DATE: June 14, 2024
TO: ALL PLAN HOLDERS OF RECORD
FROM: HUNTER SWATEK, AIA, PROJECT MANAGER
PROJECT: RAINBOW CITY RECREATION CENTER
GMC PROJECT NO. ABHM230021
RE: ADDENDUM NO. 2 AND
ACKNOWLEDGEMENT OF RECEIPT OF ADDENDUM NO. 2

ADDENDUM NUMBER 02

**PROJECT: RAINBOW CITY RECREATION CENTER
GM&C PROJECT NO. ABHM230021**

J1 SOUTH ELEVATION
SCALE: 1/8" = 1'-0"

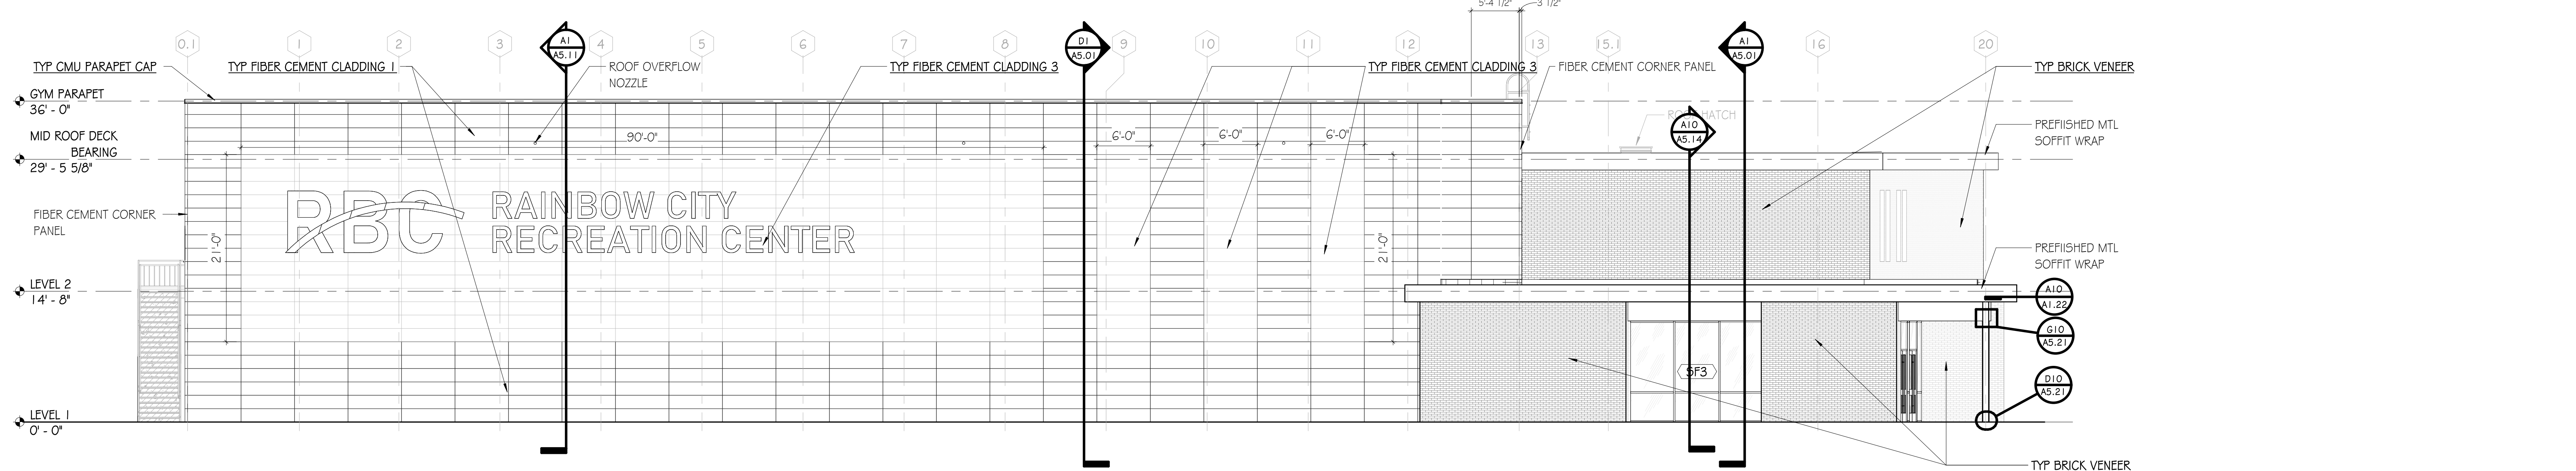
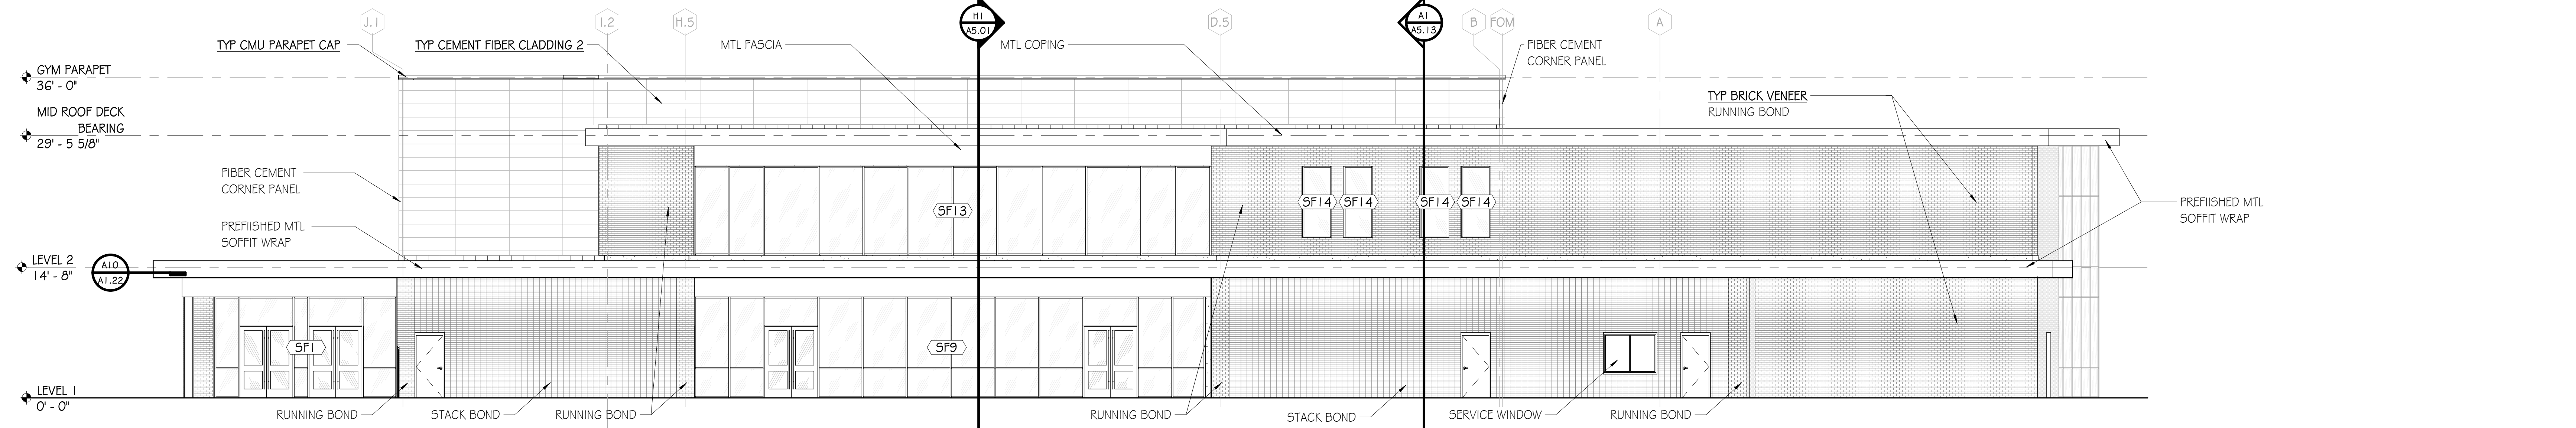
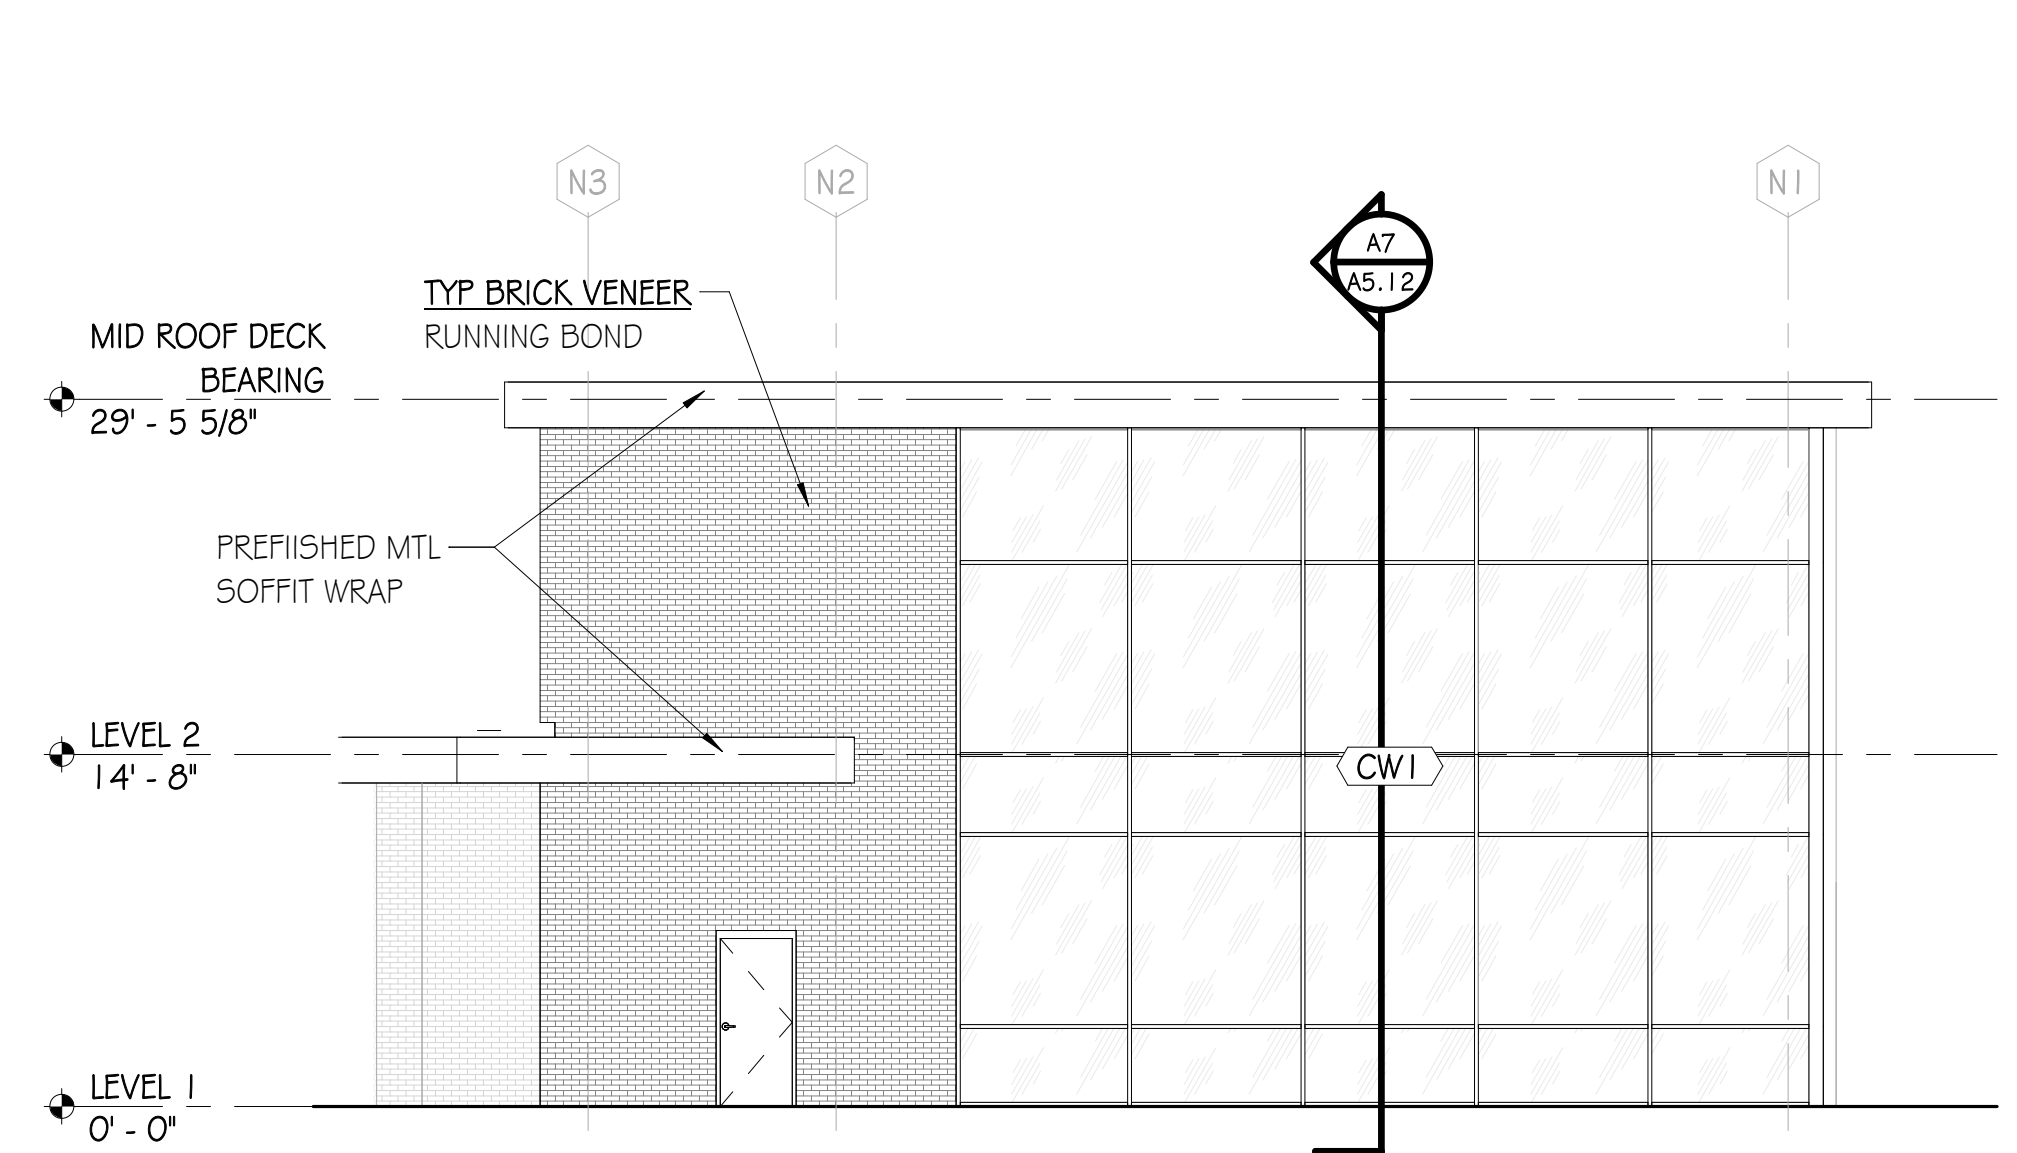
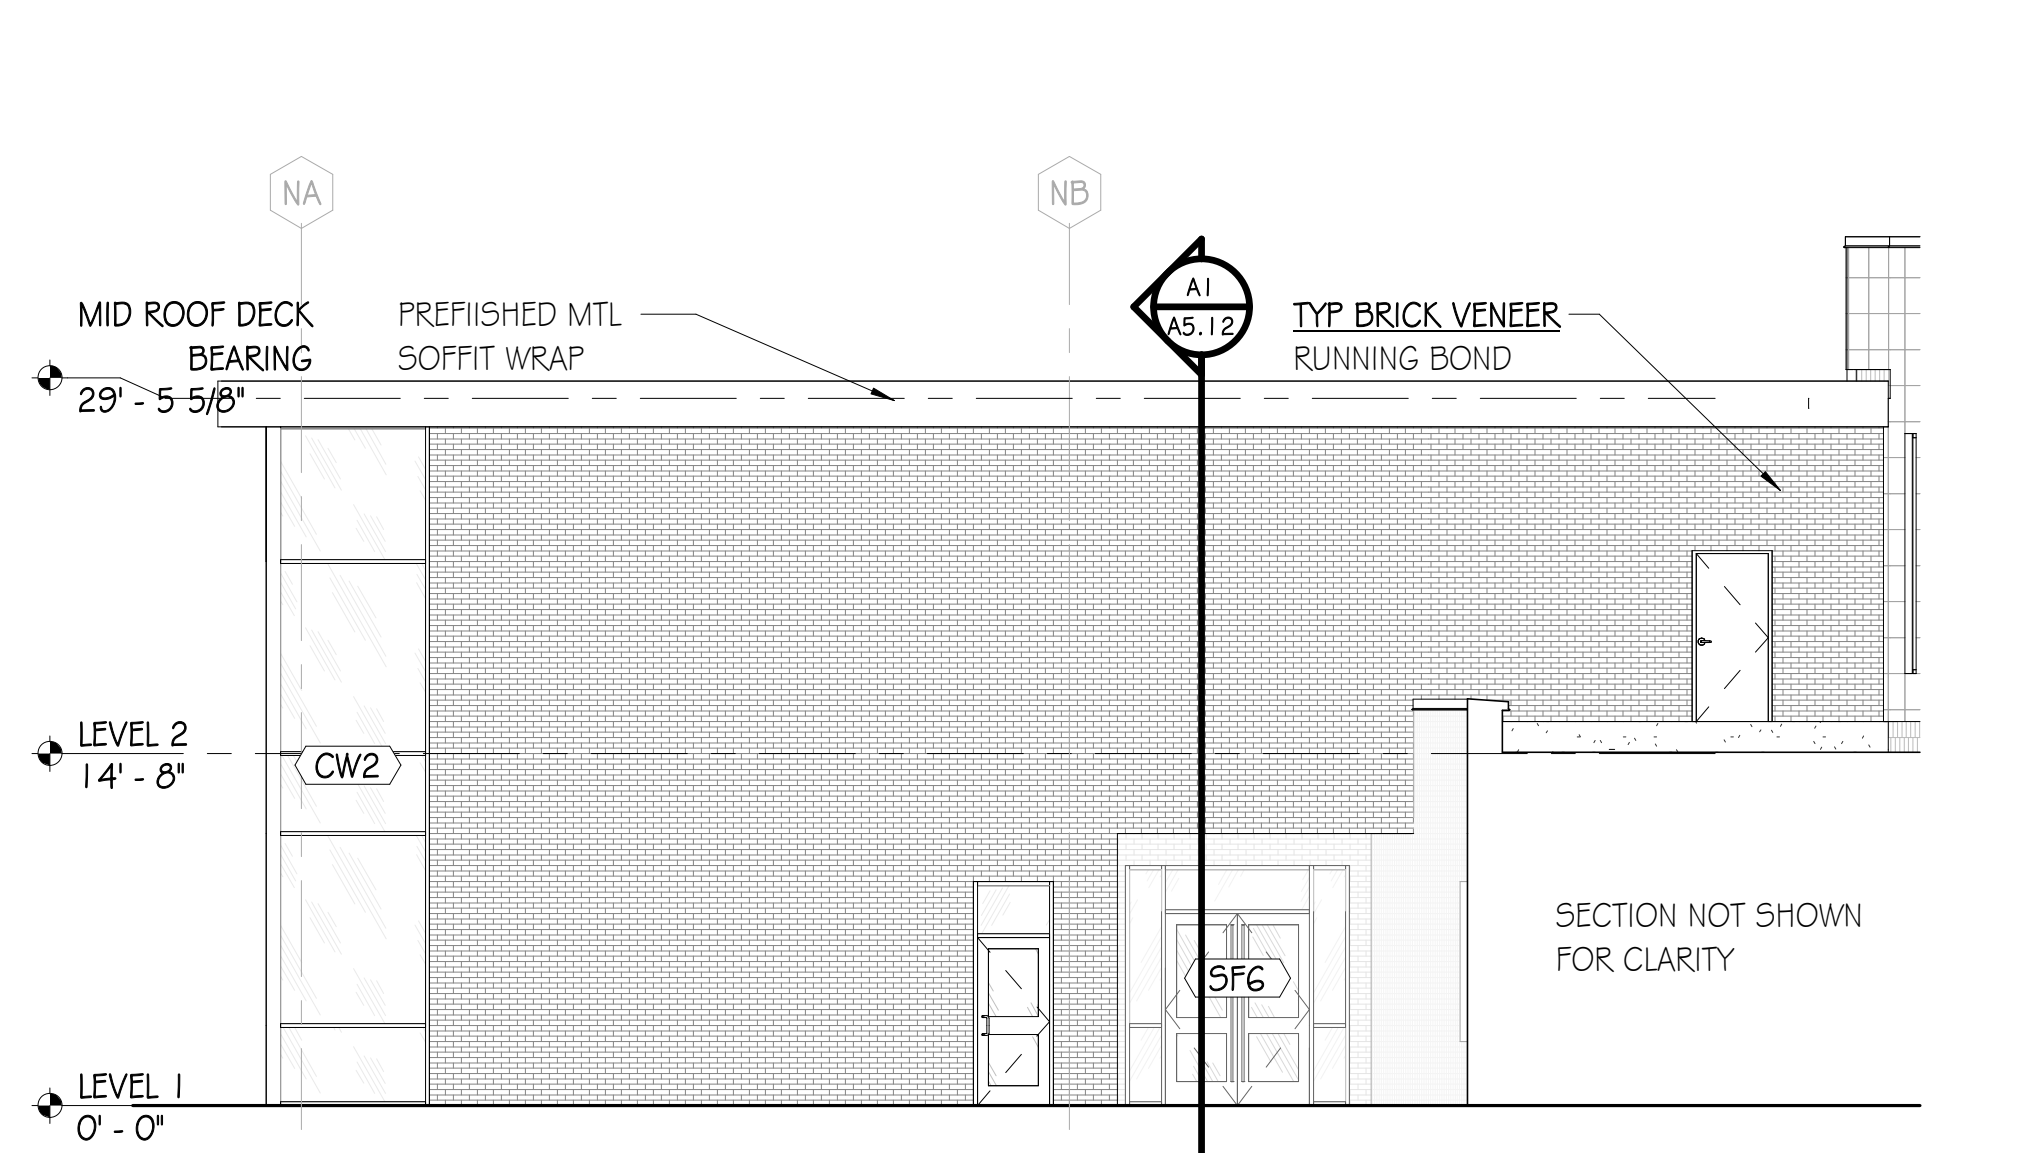
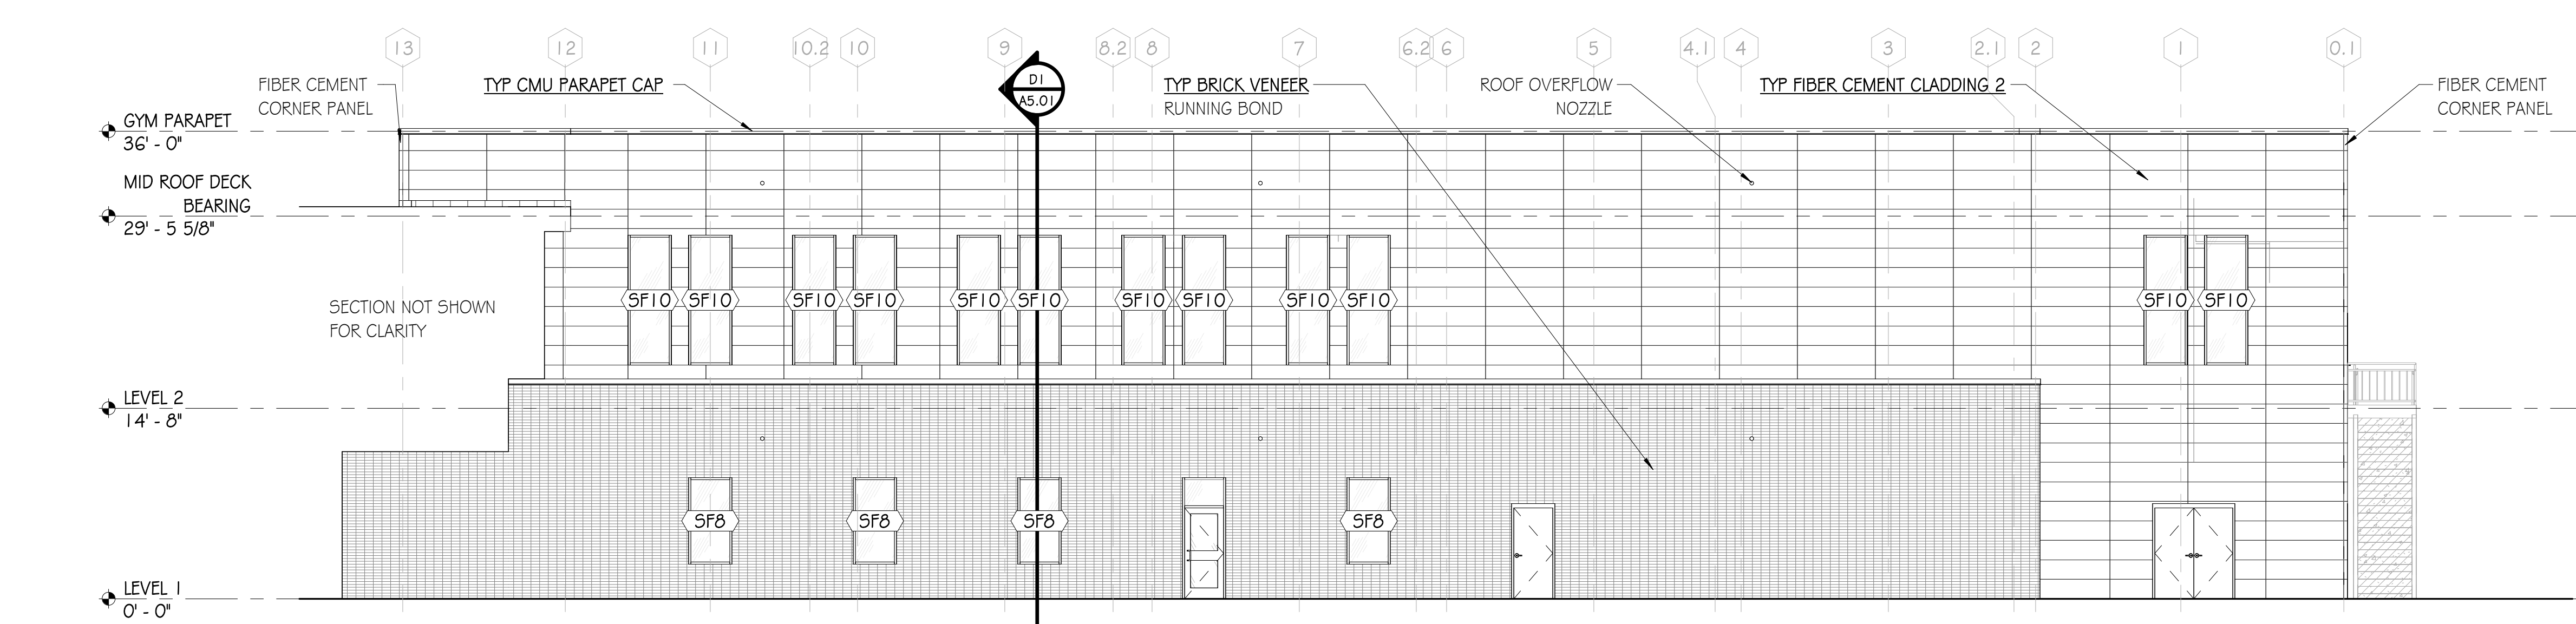
- D. **A3.03** Roof Details
 - a. REVISED Blocking
- E. **A4.01** Exterior Elevations
 - a. REVISED Fiber Cement Panel Pattern / Placement
 - b. REVISED Parapet Overflow Nozzles
